VOLLMER RV STORAGE
EROSION CONTROL PLAN

SHEET 3 OF 13
JOB NO. 25251.00

V4_Grading & Erosion Control Plan.pdf Markup Summary

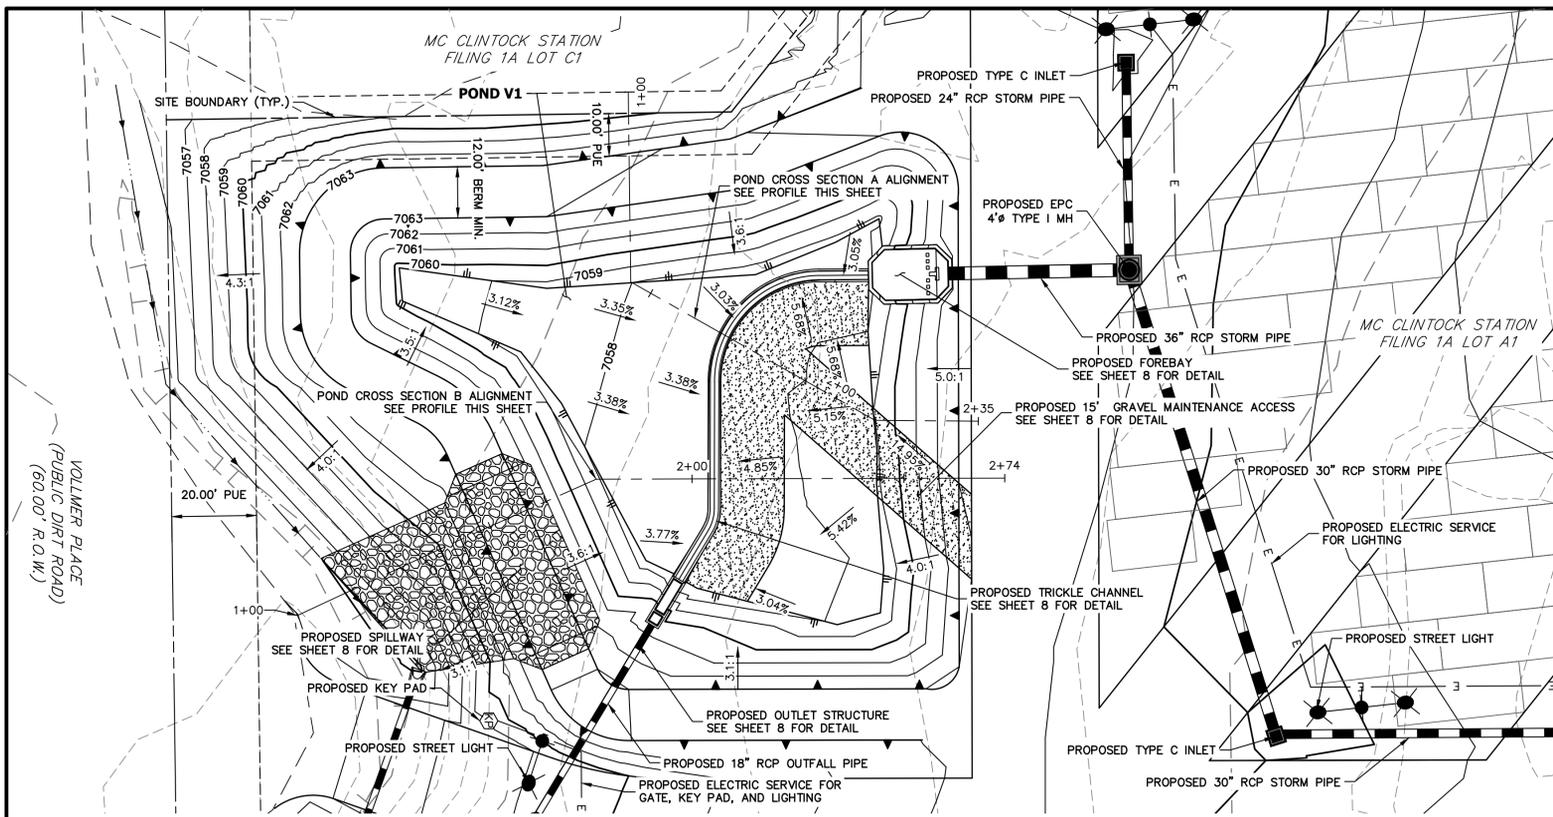
Roadway will need to meet ECM Standard SD_2-10 for Rural Gravel Local Roadway.

Work in ROW permit will be required to any work done within County ROW.

POND PLANS

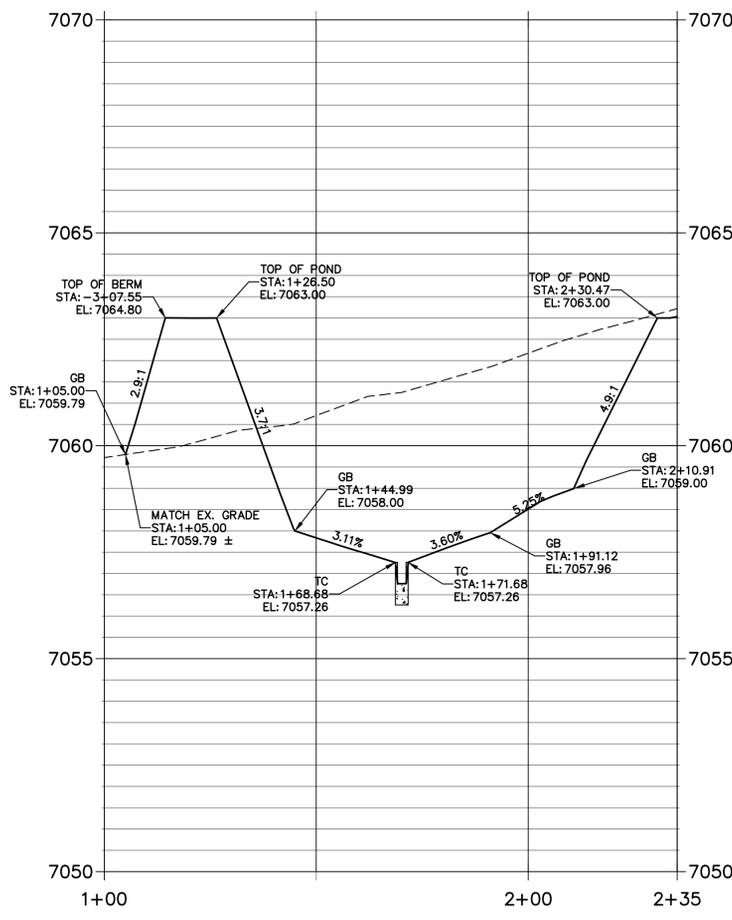
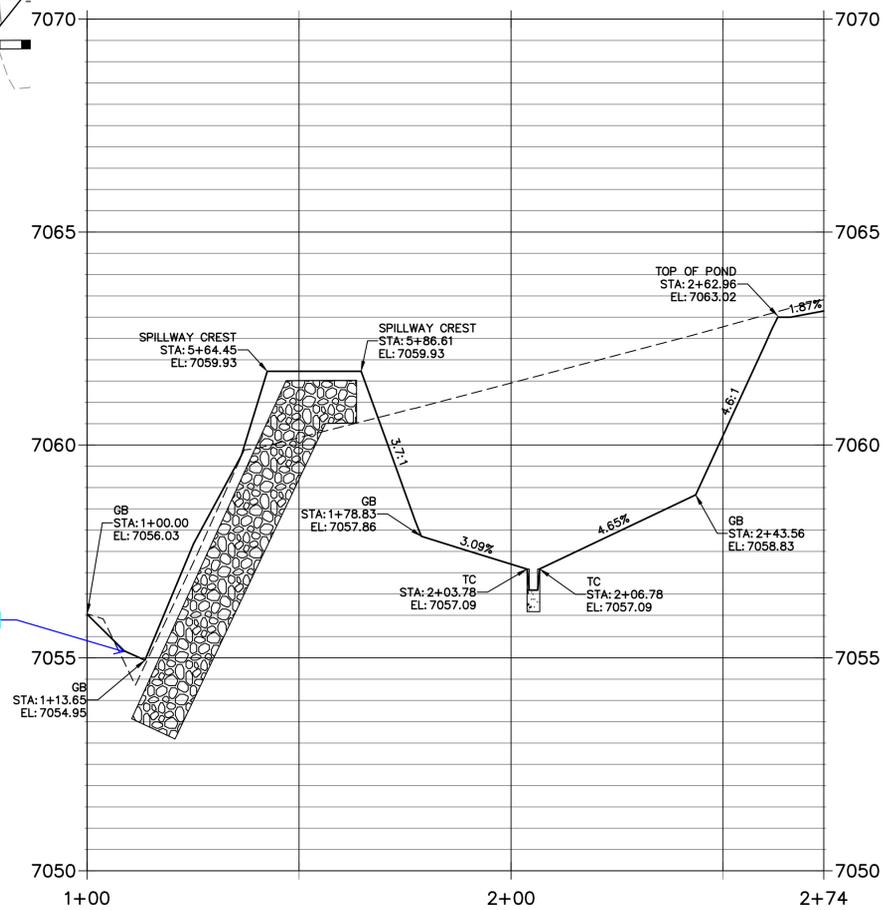
Label grade break

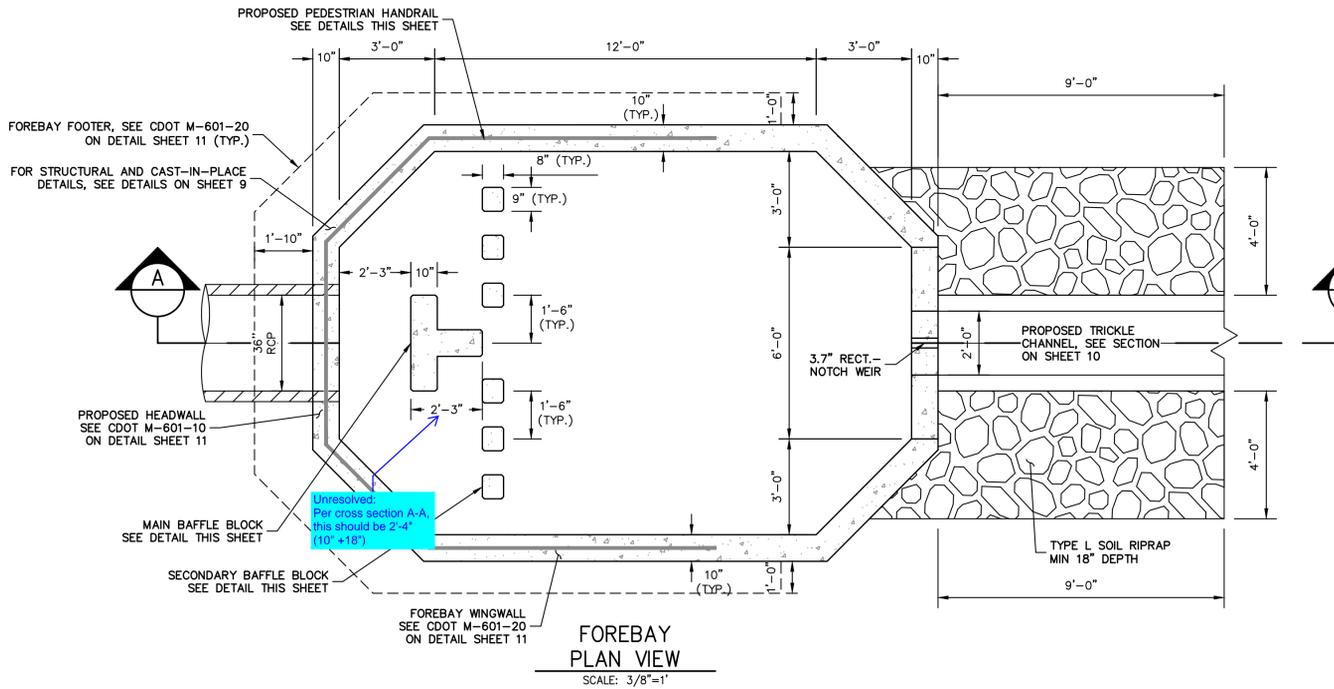
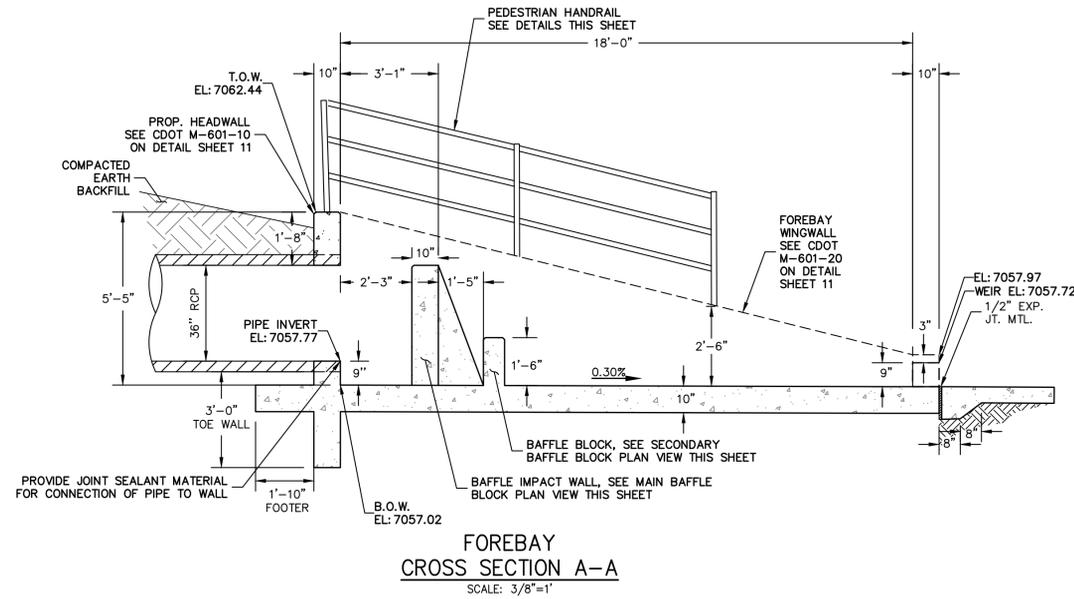
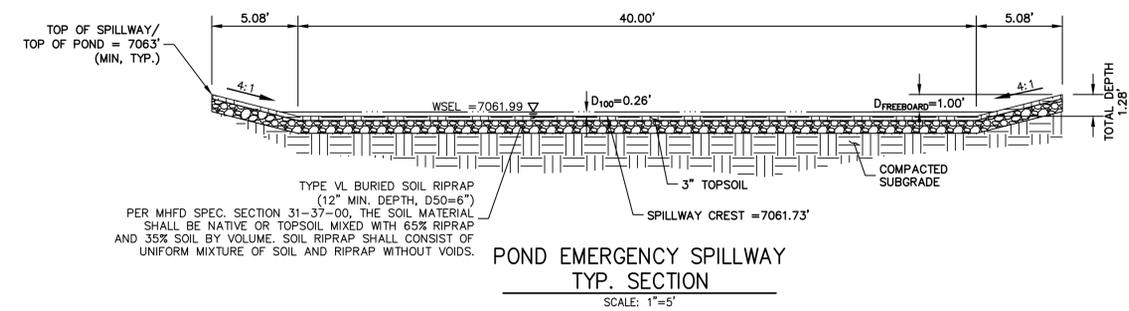
Unresolved:
Per cross section A-A, this should be 2'-4" (10" +18")
